DATE:	July 1, 2025
MAI NO.:	24001
DSA APPL. NO.:	02-122658
DSA FILE NO.:	10-28
PTN:	62125-41

**NEW CLASSROOM WING AT
SUNSET ELEMENTARY SCHOOL
COALINGA-HURON UNIFIED SCHOOL DISTRICT
COALINGA, KINGS COUNTY, CALIFORNIA**

ADDENDUM NO. 3

E5.1 R

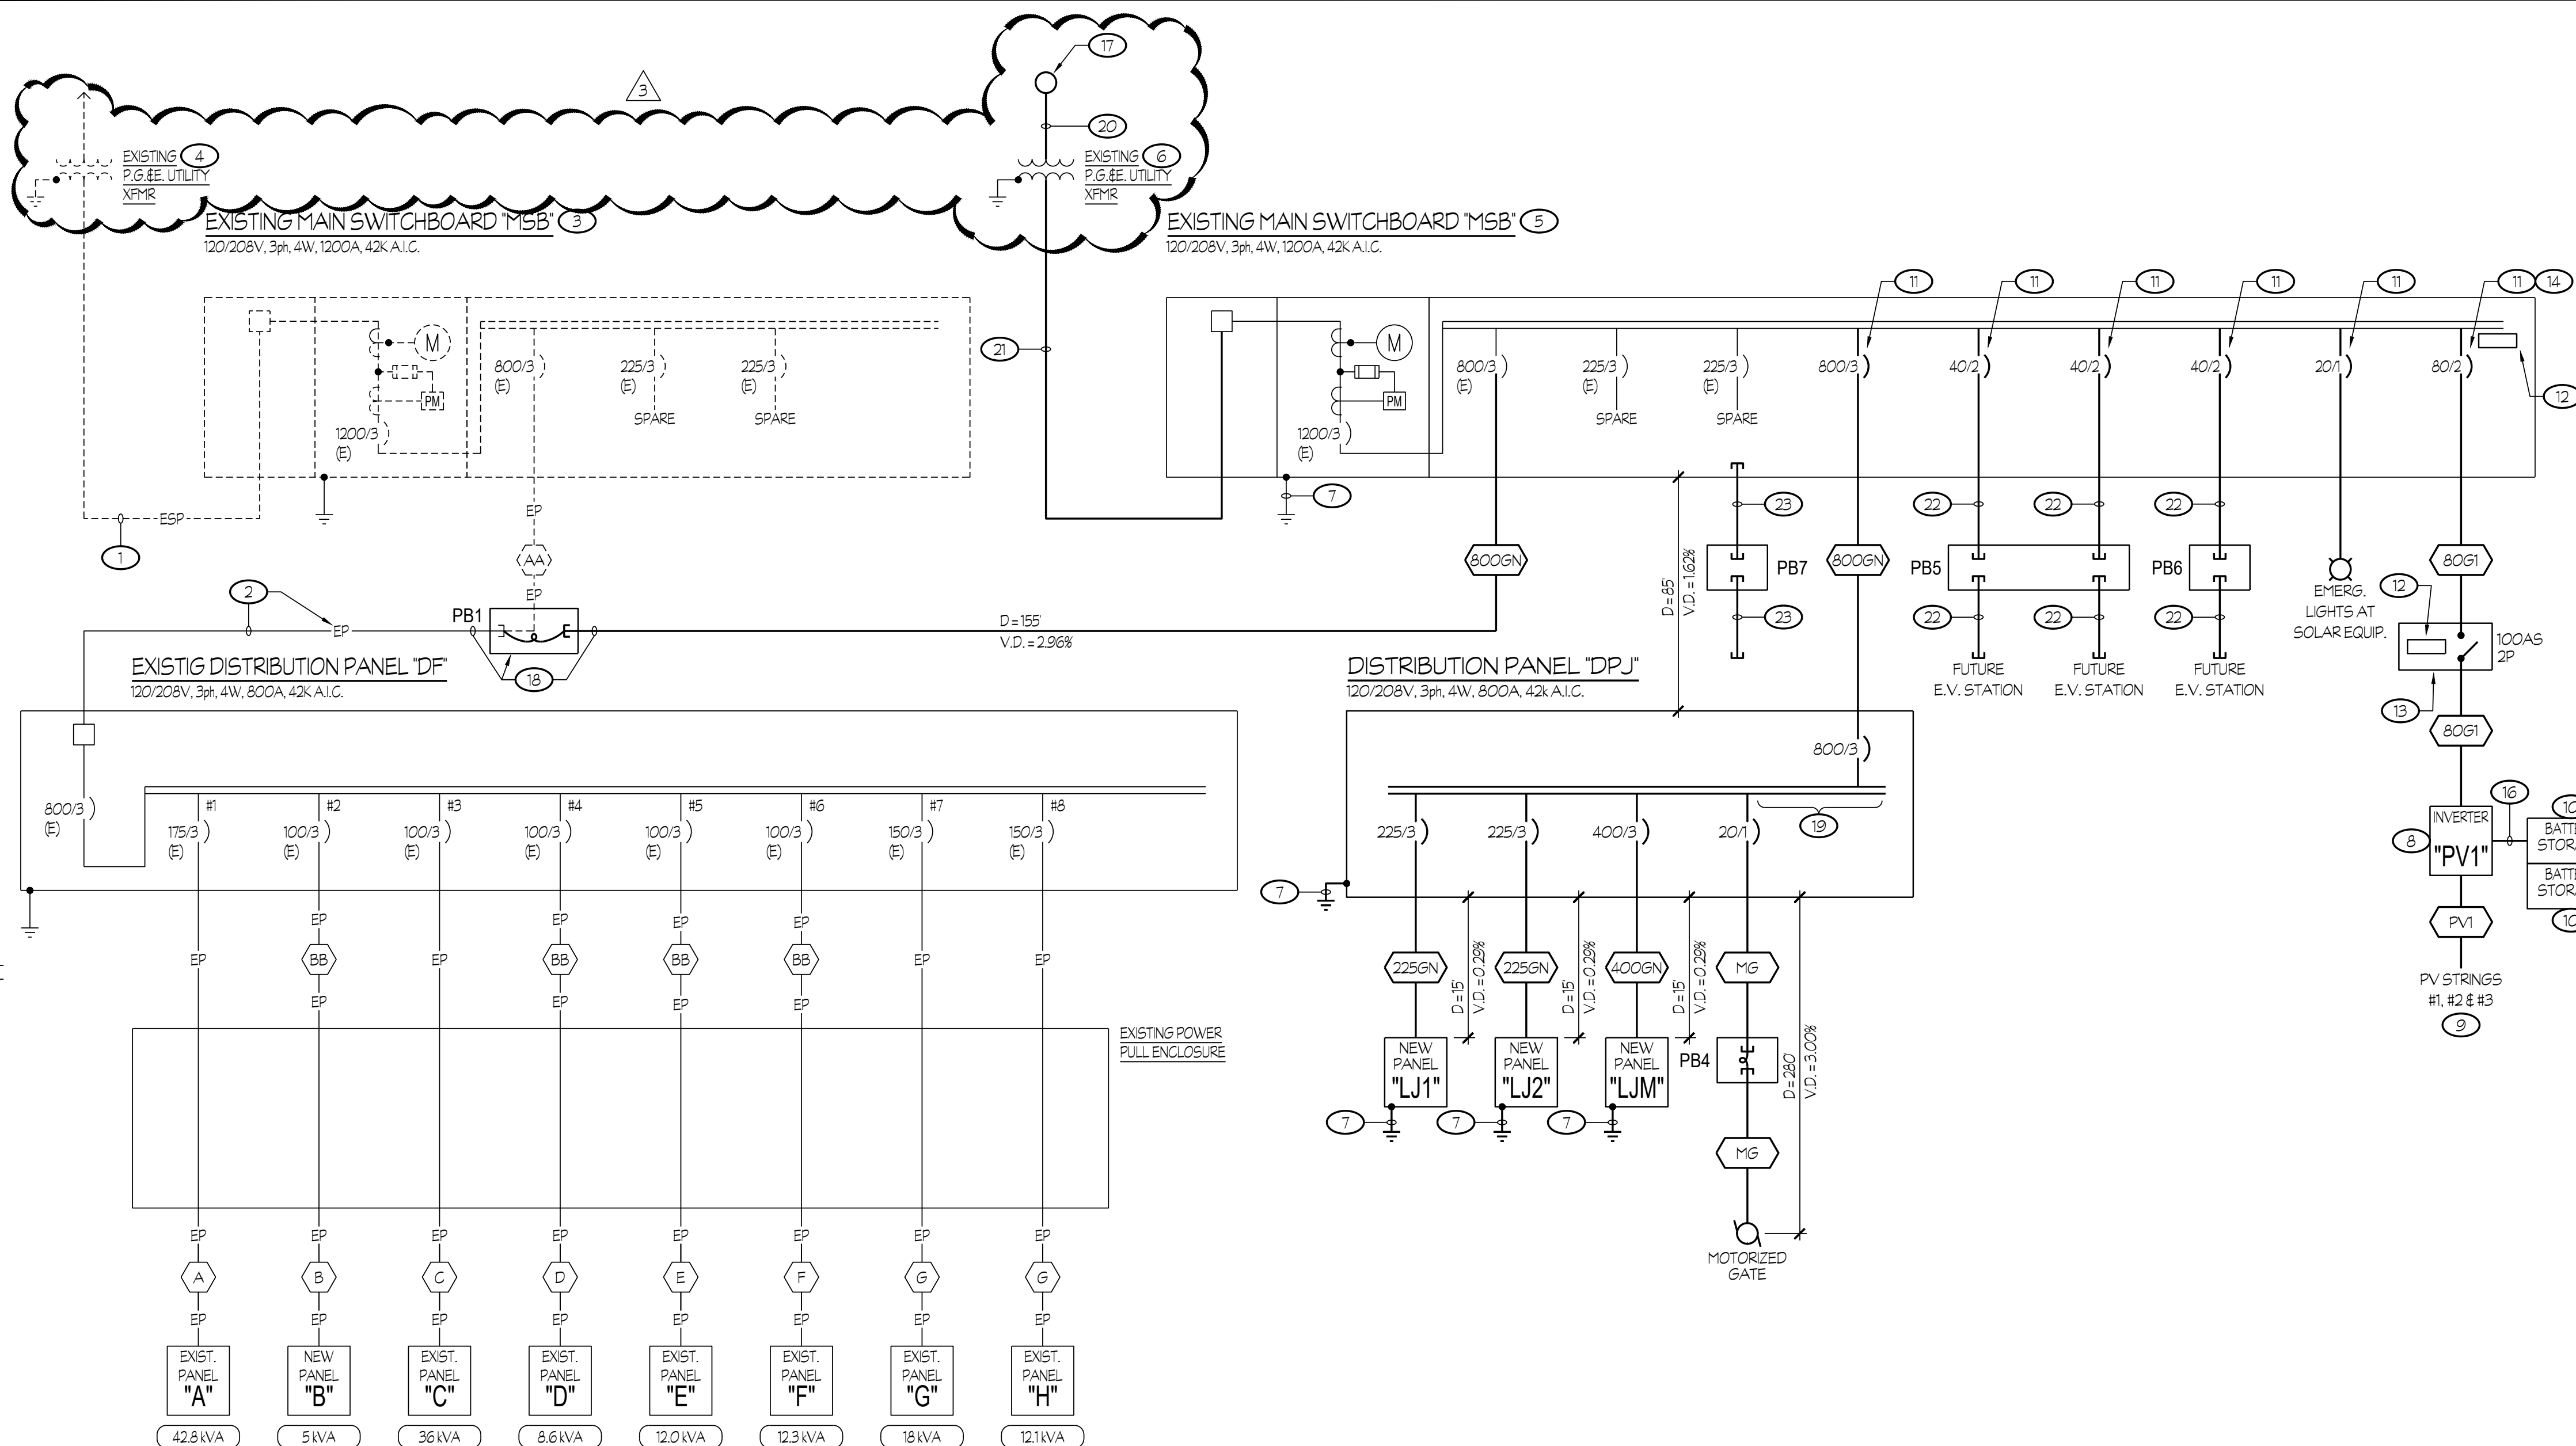
Replace with attached Sheet E5.1R with clouded changes
